PG&E Letter HBL-20-005

Docket No. 50-133, OL-DPR-7
Humboldt Bay Power Plant Unit 3
Annual Radioactive Effluent Release Report for 2019

Enclosure 2 contains Revision 29 to the "SAFSTOR/Decommissioning Offsite Dose Calculation Manual" as required by Section 4.2 of the "SAFSTOR/Decommissioning Offsite Dose Calculation Manual."

**HUMBOLDT BAY POWER PLANT UNIT 3
ANNUAL RADIOACTIVE
EFFLUENT RELEASE REPORT**

Figure 2-1
HBPP Onsite TLD Locations

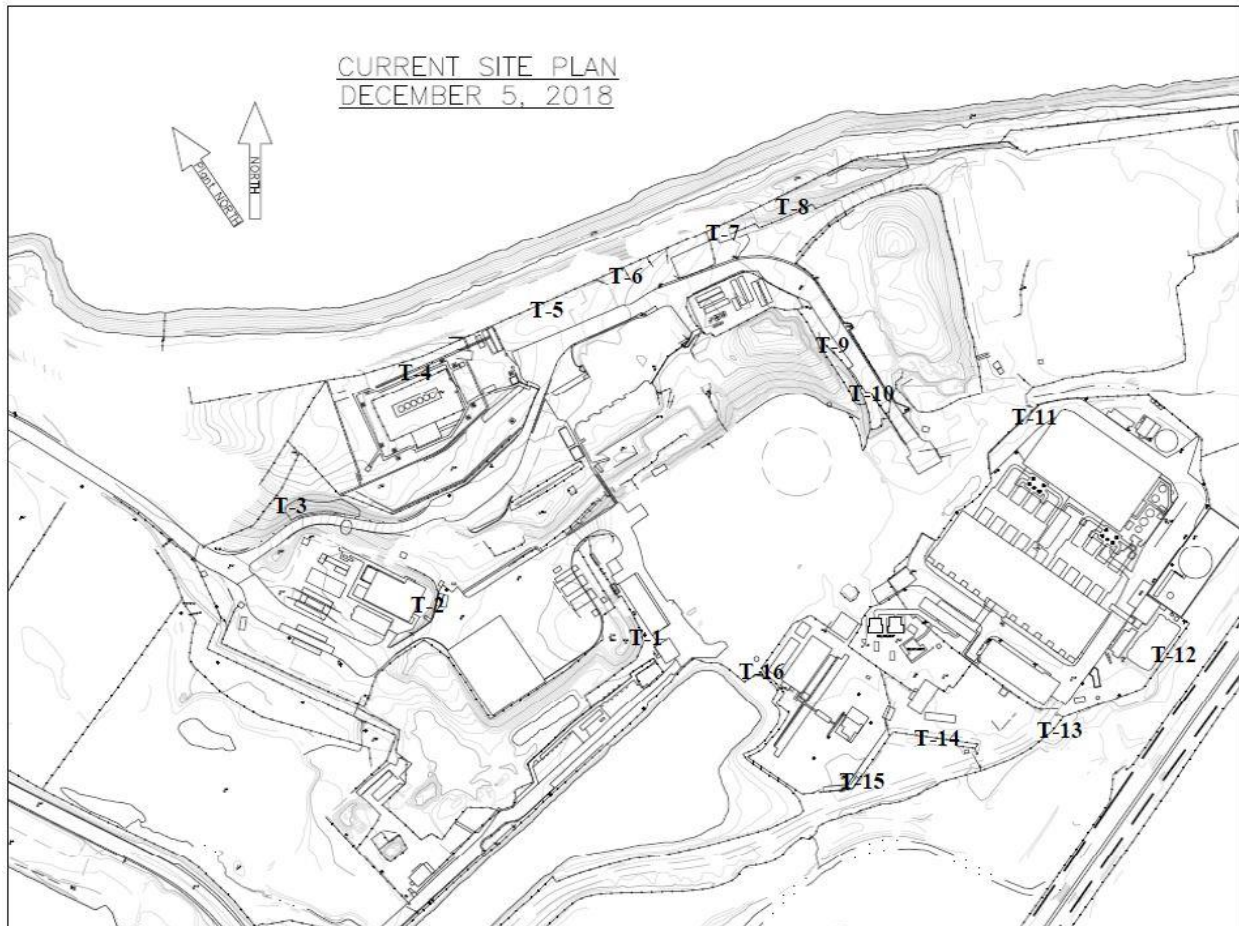
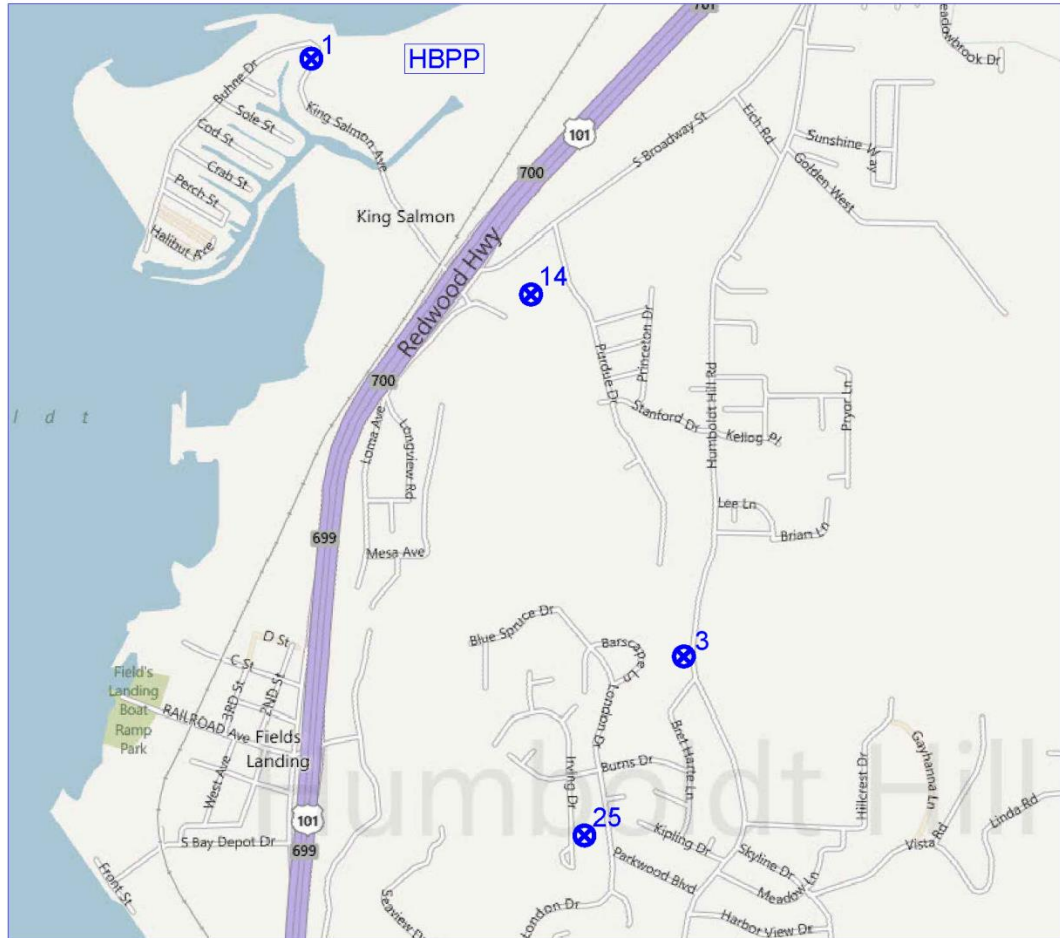
Page / Section	Change Date	Change	Reason
Page I-22 Figure 2-1	Rev. 29	Locations T-2, T-9, T-10, and T-11 moved during 2018.	Thermoluminescent dosimeter locations reflect changes in the perimeter fencing and areas that are no longer controlled to prevent pubic access.

Figure 2-1
HBPP Onsite TLD Locations

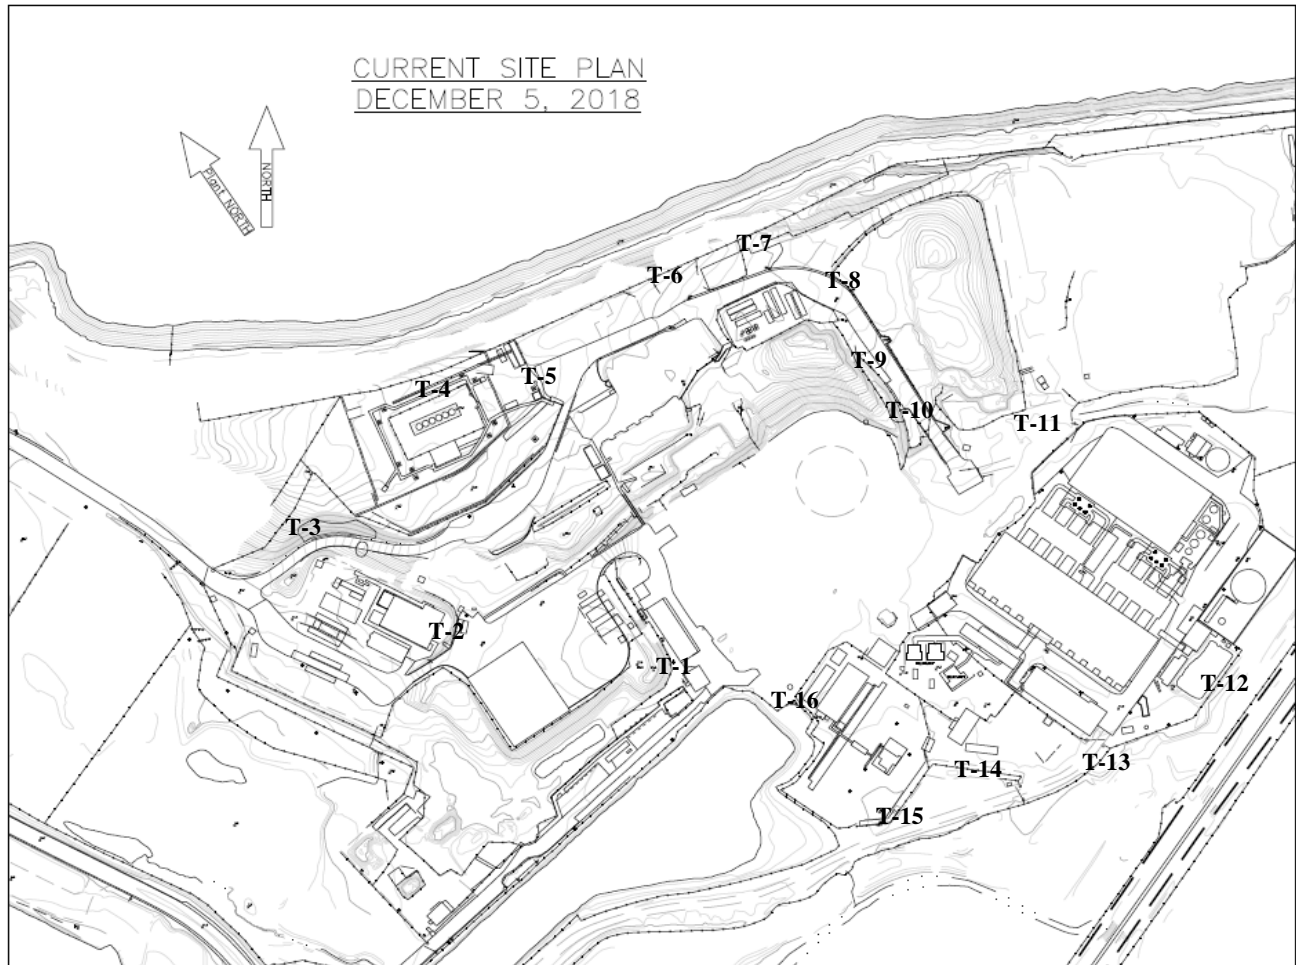
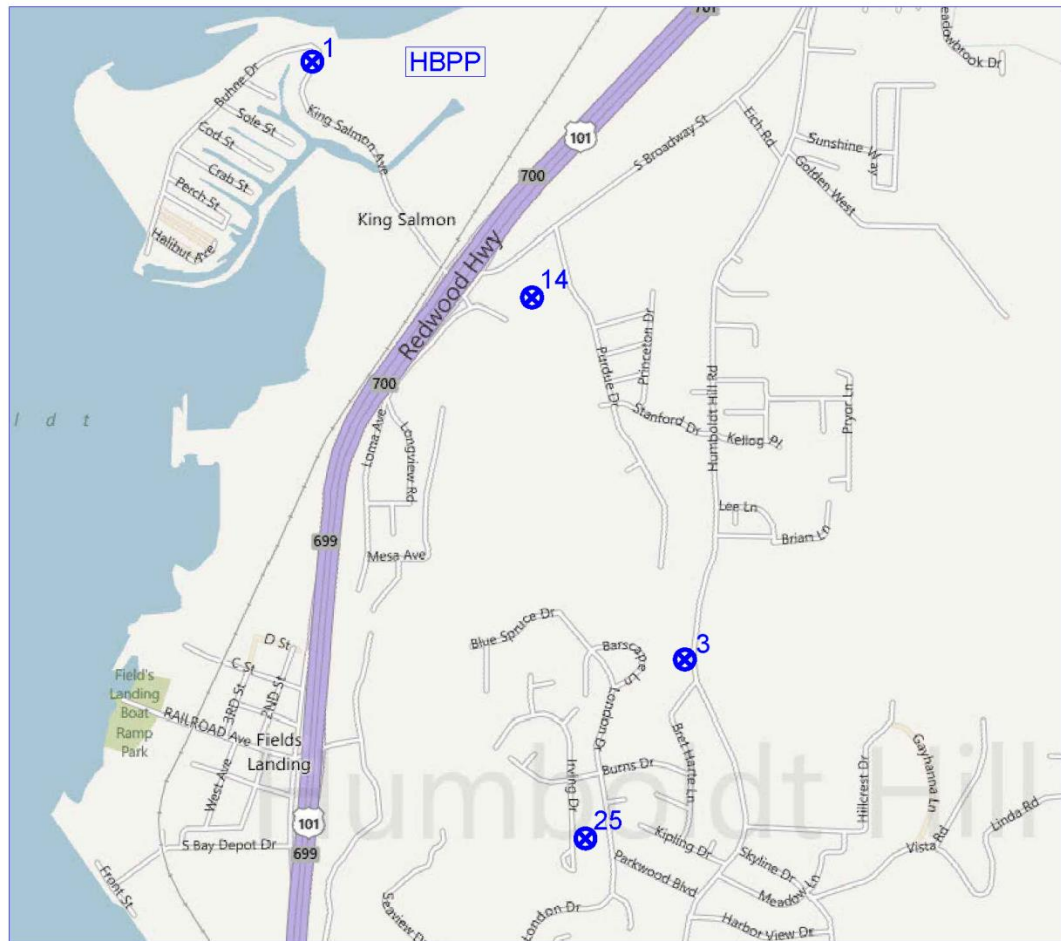
Page / Section	Change Date	Change	Reason
Page I-22 Figure 2-1	Rev. 30	Locations T-5, T-6, T-7, T-8, and T-11 were moved during 2019.	Thermoluminescent dosimeter locations reflect changes in the perimeter fencing and areas that are no longer controlled to prevent pubic access.
Page I-18 Table 2-7	Rev. 30	Onsite Airborne Monitoring Locations reduced from 4 to 3	There is no source of airborne contamination, no perceived receptor or routinely exposed individual in this area, collecting air samples no longer provides useful information.
Page A-2 Appendix A, 1.1	Rev. 30	Removed the discussion about the Ground Water Treatment System. Added: The Ground Water Treatment System (GWTS) was removed from service in April 2019.	Storm water monitoring is provided through the Storm Water Pollution Prevention Plan and installed engineered features as a part of the final site restoration for that purpose.

**Figure 2-3
HBPP OFFSITE SAMPLING LOCATIONS - HUMBOLDT HILL**

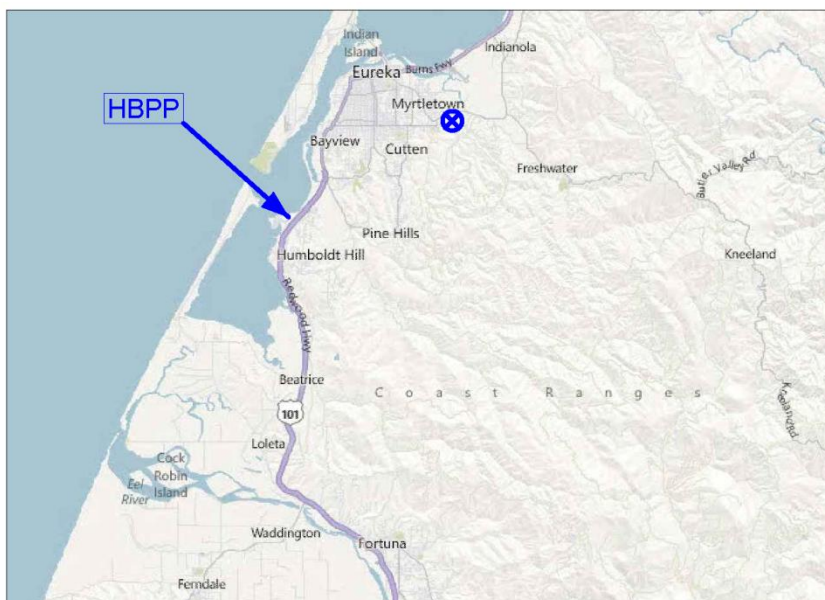
Page I-23 Table 2-10, Figure 2-3	Rev 31	Delete Humboldt Hill Road air sample location 3	Onsite air samples are an indication of the environmental impact from the site. With no stack and no effluent pathway, the offsite location provides no value added.
